**Victorian Planning Authority Projects Standing Advisory
Committee – Referral No. 4
Craigieburn West Precinct Structure Plan**

Advisory Committee Report

17 June 2021

Craigieburn West Precinct Structure Plan

Figure 7 Drainage Services Scheme boundaries

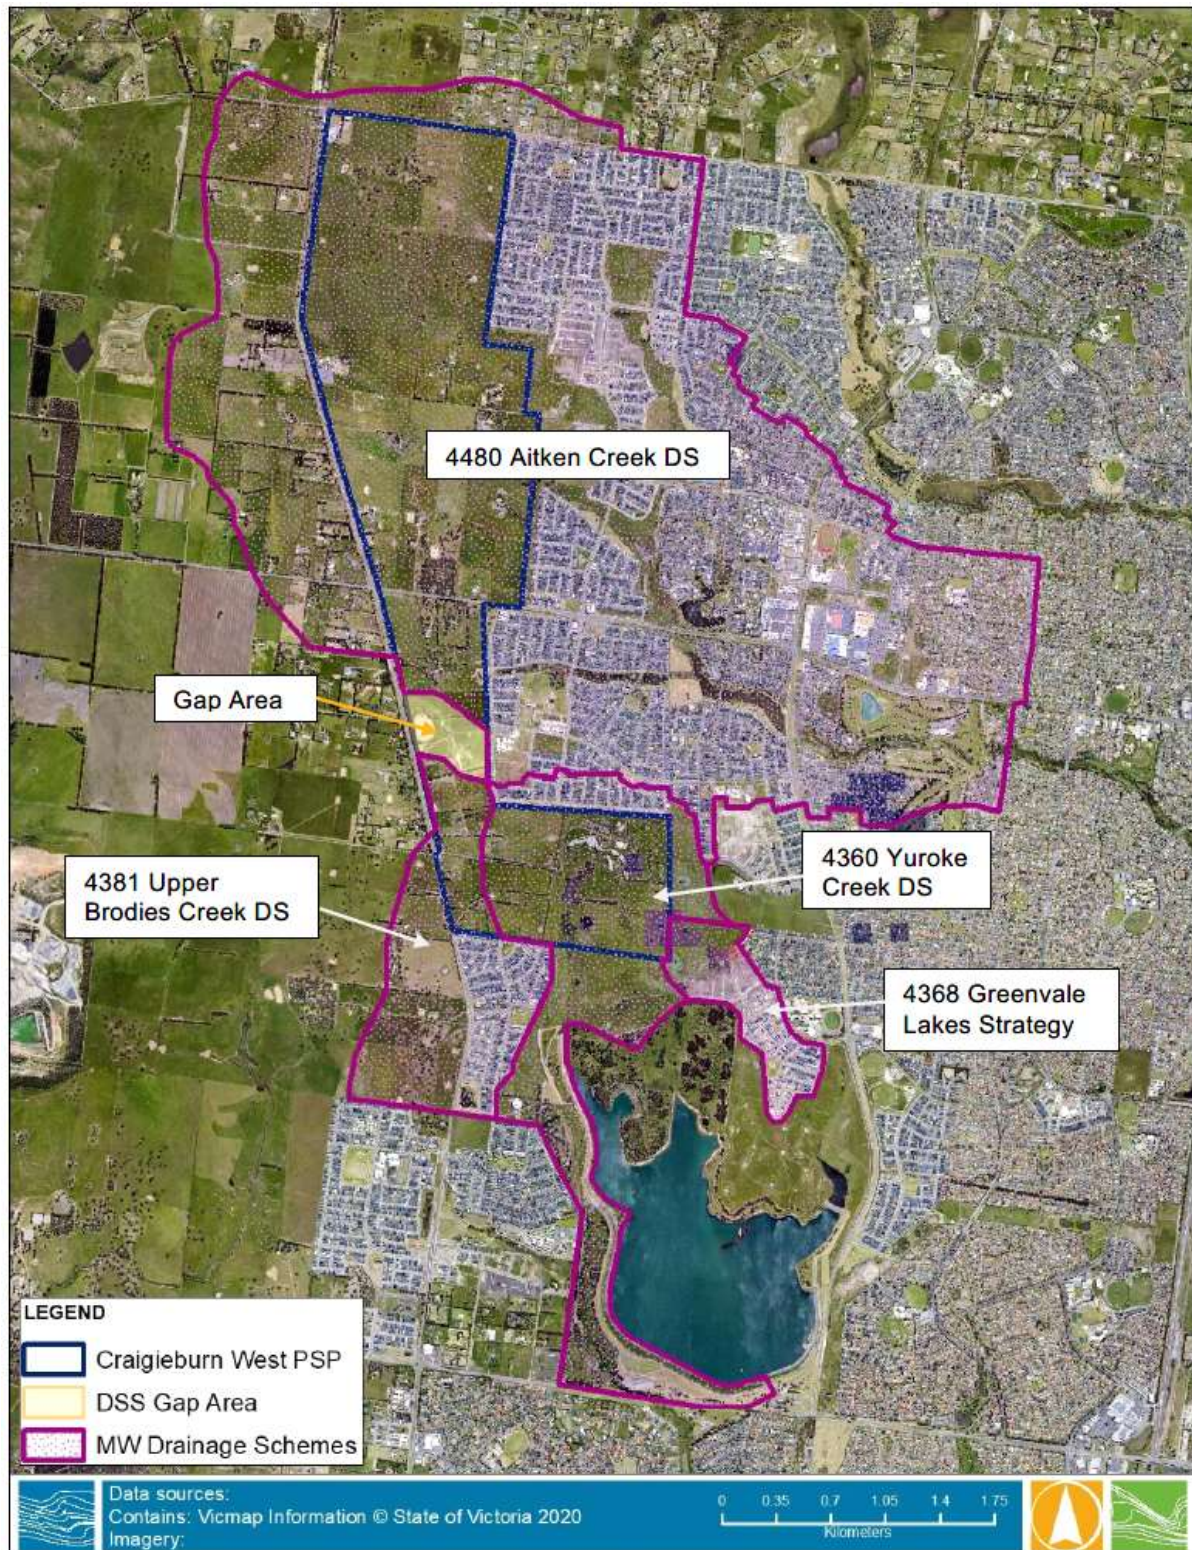
The location of the PSP and DSSs are shown in Figure 7. The Integrated Water Management Plan is extracted below in Figure 8.

7. **Amend the Integrated Water Management Plan (Plan 6) to show the amended boundaries of the Aitken Creek Drainage Services Scheme and the Yuroke Creek Drainage Services Scheme as outlined in Figure 2 of Mr Mag's evidence (Document 34).** [Chapter 4.6]
8. **Amend the walkable catchment boundaries to extend:** [Chapter 5.3]
 - a) **west of the Local Town Centre to a distance of 90 metres inboard from Mickleham Road**

Figure 15 Proposed northern primary school location

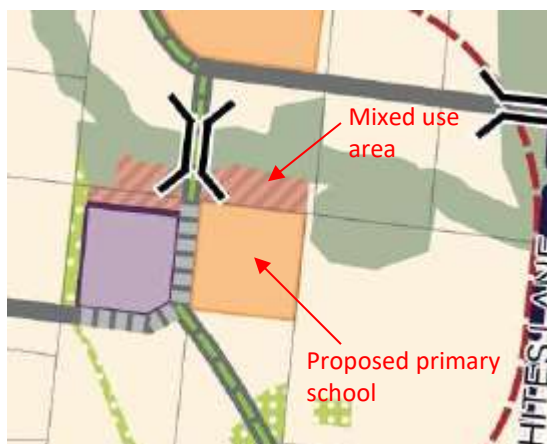
The PSP proposes to locate the northern government primary school next to the LTC, with a strip of mixed use between the school and the Aitken Creek drainage reserve (see Figure 15).

Figure 17 Stockland alternative Place Based Plan based on Conservation Area boundary realignment

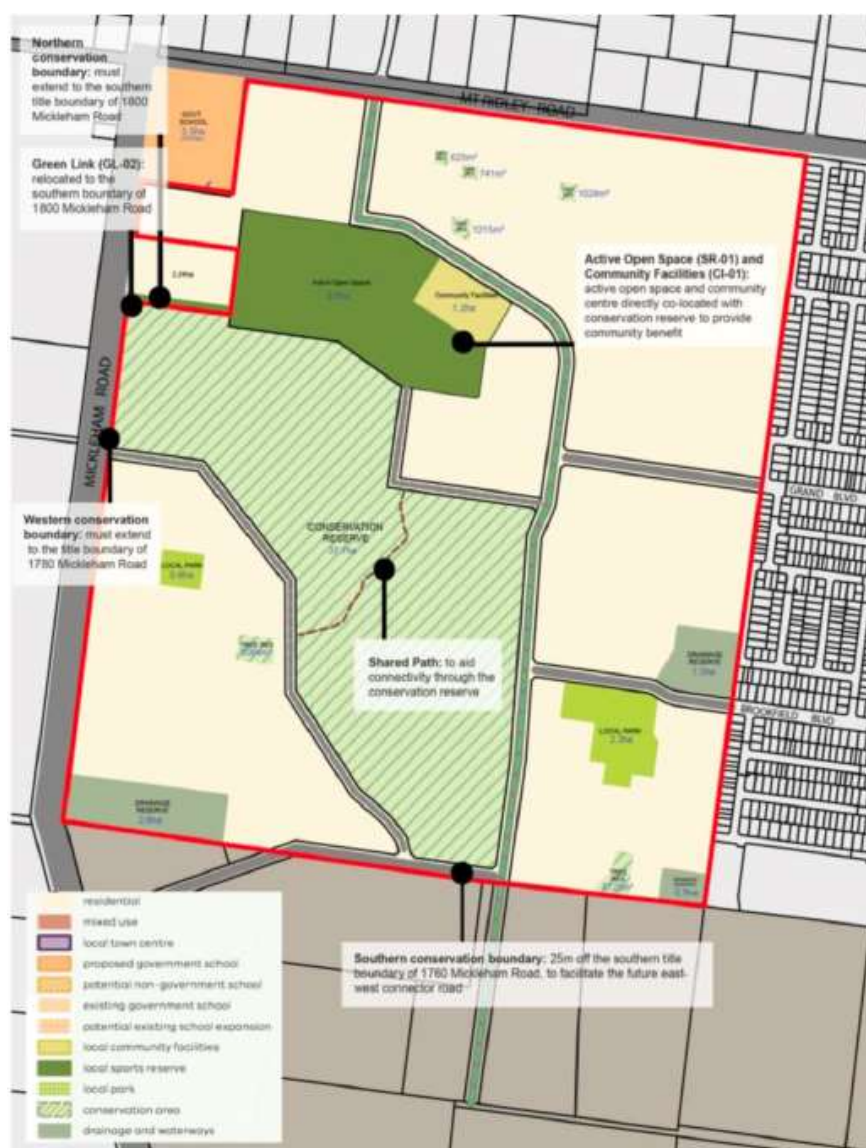
Stockland proposed relocating SR-01 in response to the proposed realignment of the Conservation Area boundaries (see Figure 17 in Chapter 8.3). Stockland called planning evidence from Mr Negri, who noted the co-location of SR-01 with the conservation area and positioned to be accessible to the future residents of the PSP area and neighbouring precincts (Lindum Vale to the north and Craigieburn R2 to the east).

The PSP proposes to show the boundaries of Conservation Area 29 as currently approved (see Figure 3). Agreement has been reached between Stockland, the VPA, Council and DELWP to amend the boundaries as shown in Figure 17 below. Approval has been sought from the Commonwealth Government, but not yet granted.

Figure 18 Bushfire Plan

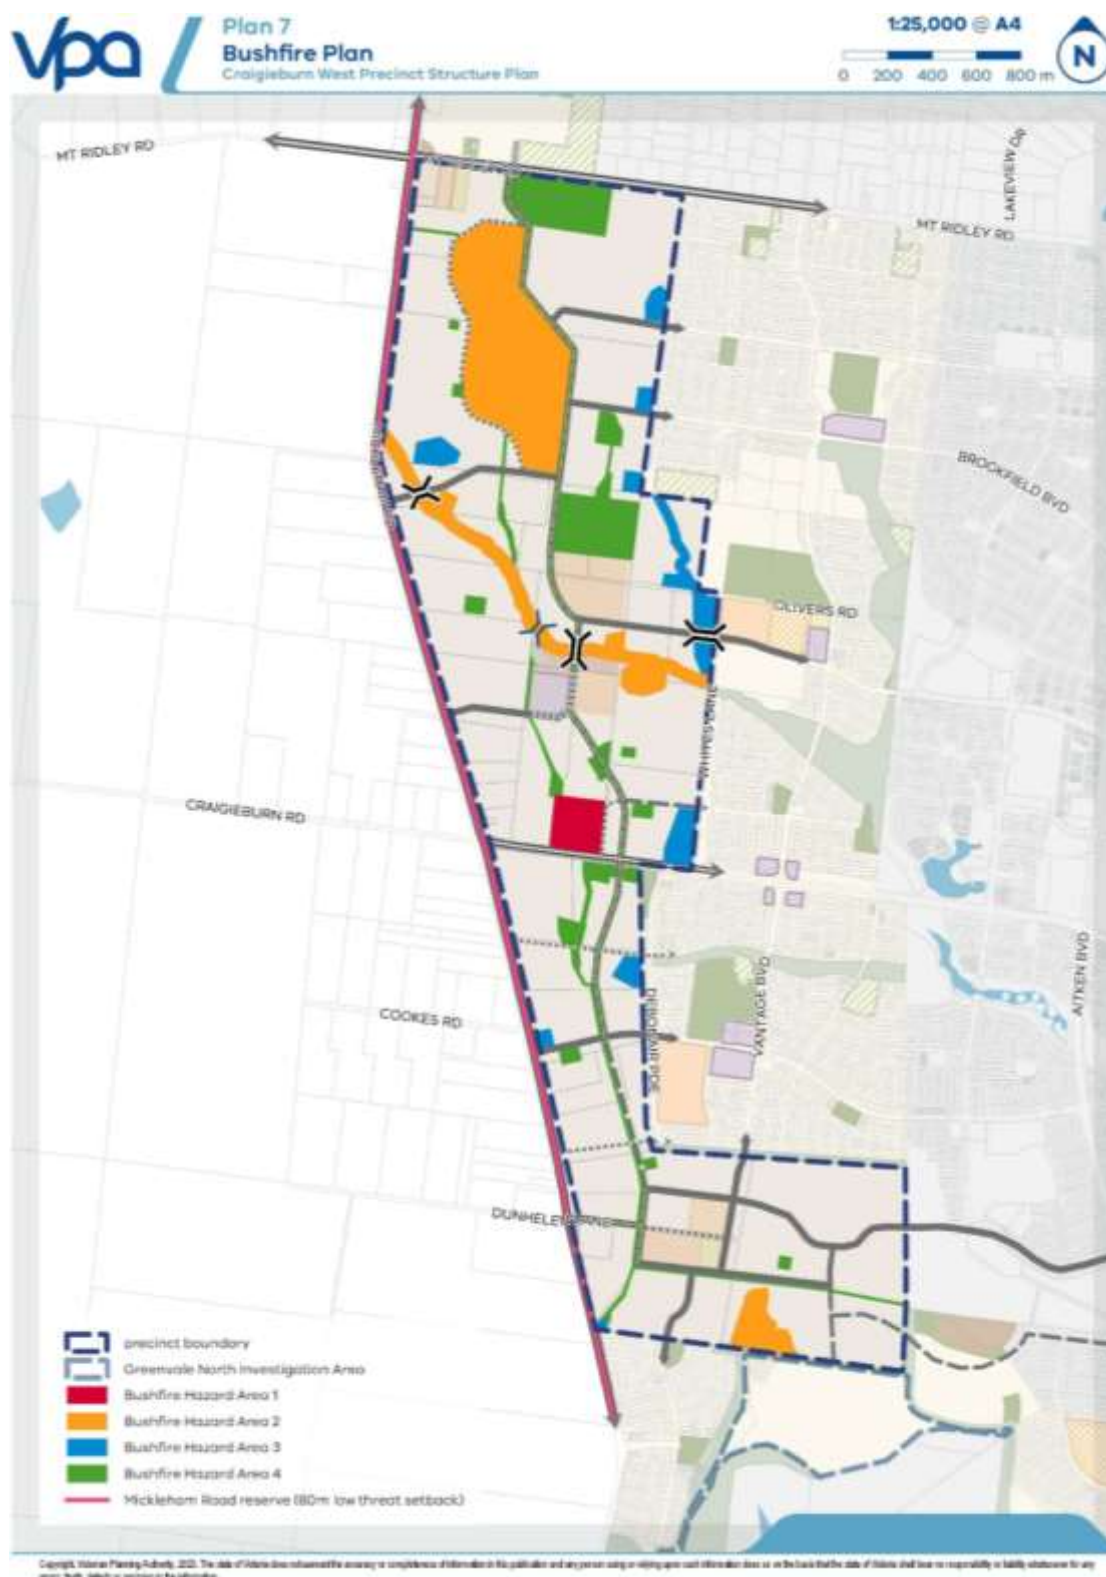
The PSP classifies the areas in the precinct that present a bushfire hazard from Hazard Area 1 (highest) to Hazard Area 4 (lowest). These are shown on the Bushfire Plan (Plan 7), extracted in Figure 18 below.
